From: Leking, Geoffrey R, EMNRD
Sent: Friday, December 07, 2012 2:20 PM
To: 'Tavarez, Ike'
Cc: Joshua Russo; Michelle Mullins (MMullins@concho.com)
Subject: RE: COG - Magnum Pronto State Com #2 Tank Battery - Work Plan Approval Request

Report Type: Work Plan

Re: Work Plan for the COG Operating LLC., Magnum Pronto State Com #2, Unit K, Section 32, Township 19 South, Range 32 East, Lea County, New Mexico.

Proposed Excavation Depths

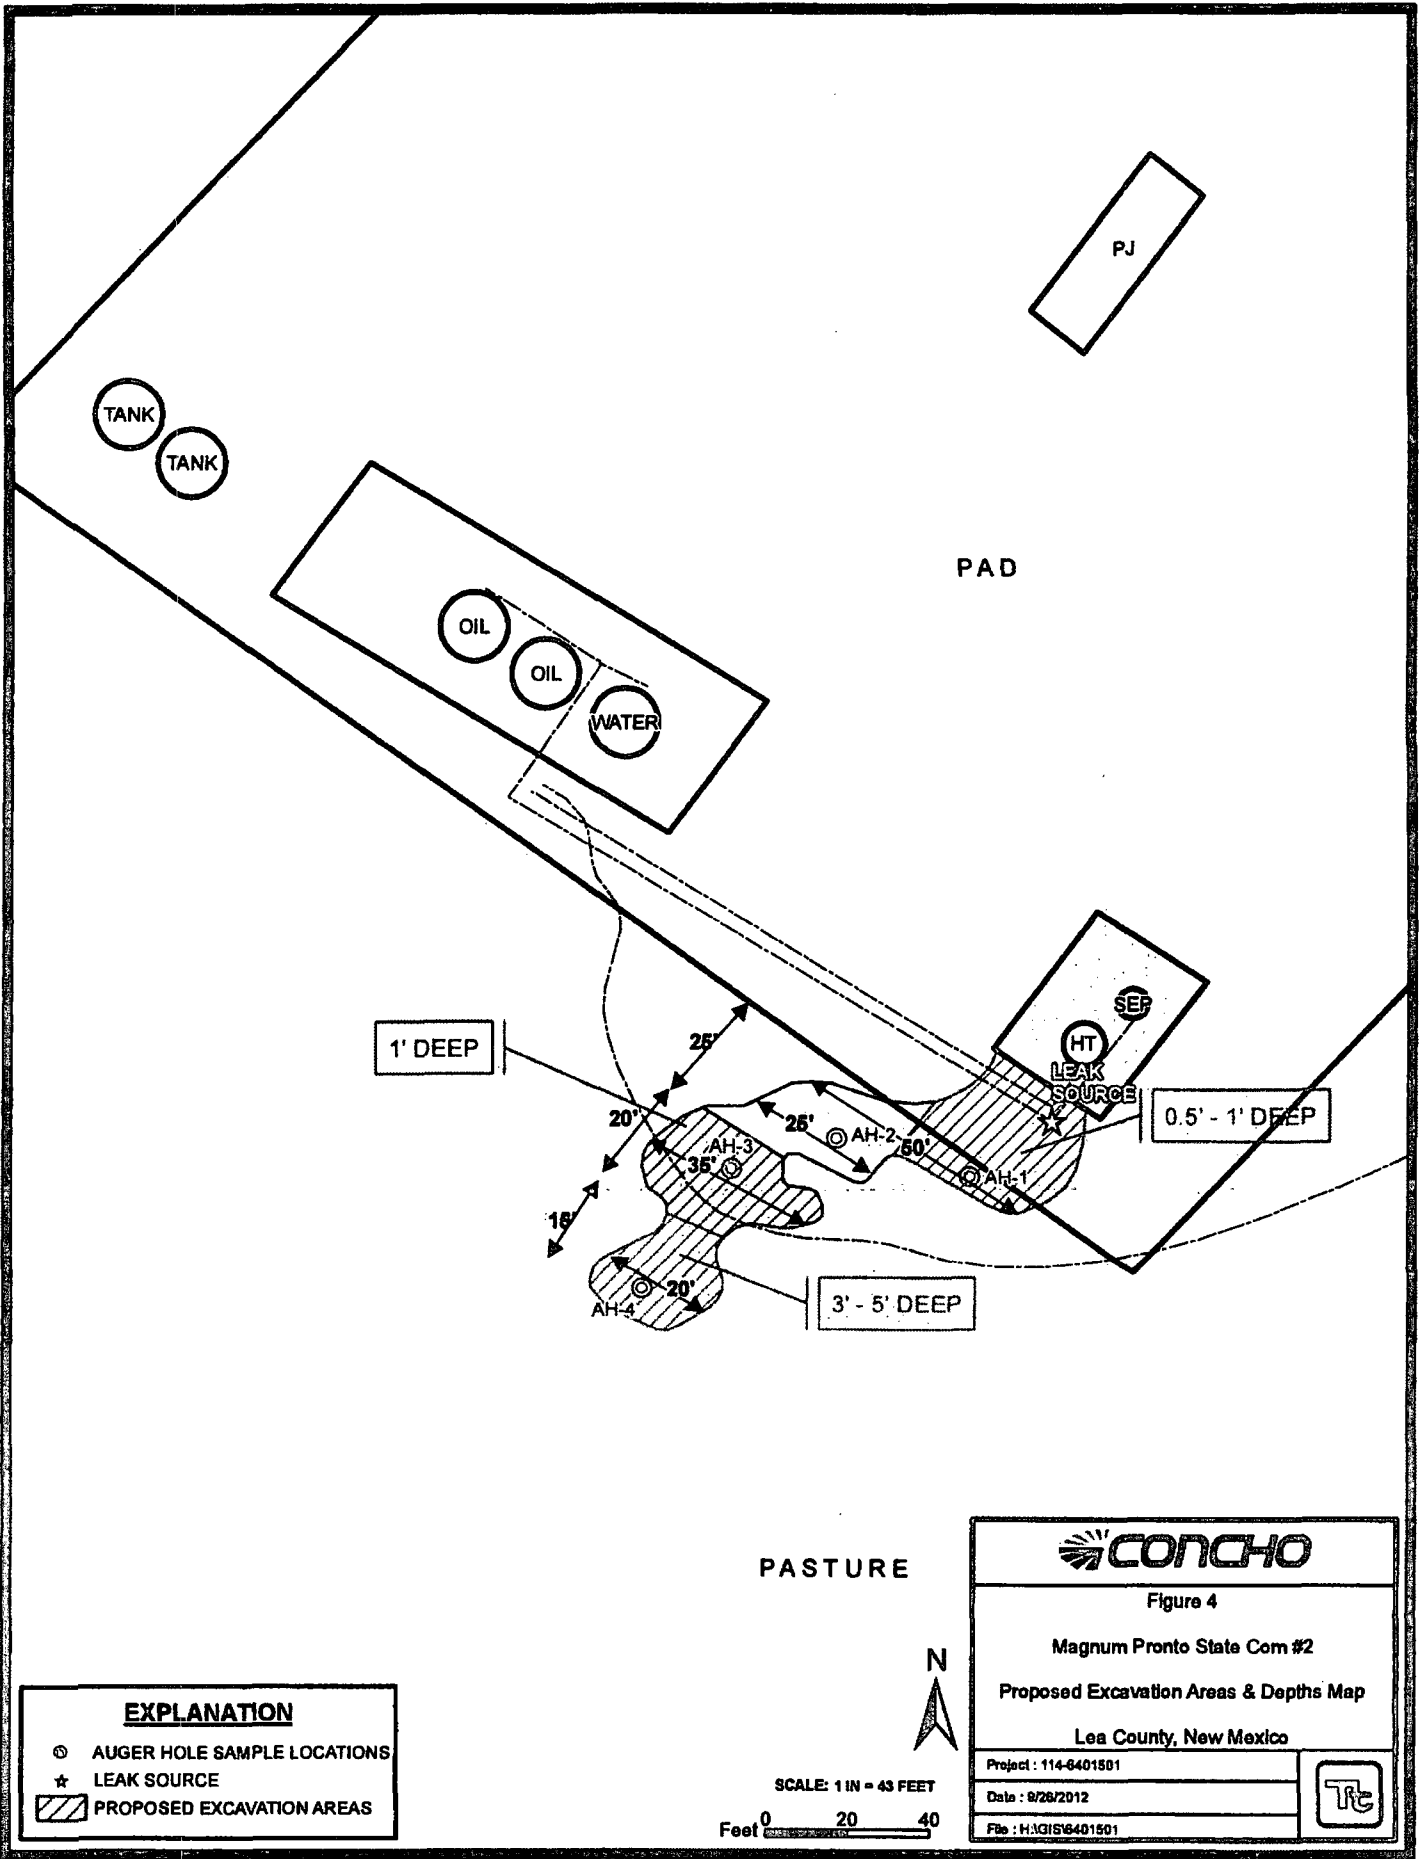
- 1) Page 2, "Work Plan" section, Para. 1 – Please indicate that additional excavation will be performed at AH-4 if the confirmation sample at 3.0' displays TPH concentrations above RRALs. It is also noted that Figure 4 indicates that contamination/excavation may extend to 5.0'.
- 2) Page 3, "Work Plan" section, Para. 1 – Please clarify the sentence, ..."However, if the chloride impact at AH-2 is limited, based upon the depth of the know impact and depth to groundwater, this area may be left undisturbed.".

- 1) The area of AH-4 will be excavated to a depth of approximately 3.0' to 5.0' below surface to remove the impacted soil above the RRAL. Once excavated, the excavation will be left open until the lab results are evaluated. If additional excavation is required, the area will be excavated deeper and repeat the process until the soil exceeding the RRAL has been removed. The proposed excavation depth (3-5') shown on Figure 4 are estimated depths, based on the TPH (shown Table 1) declining with depth.
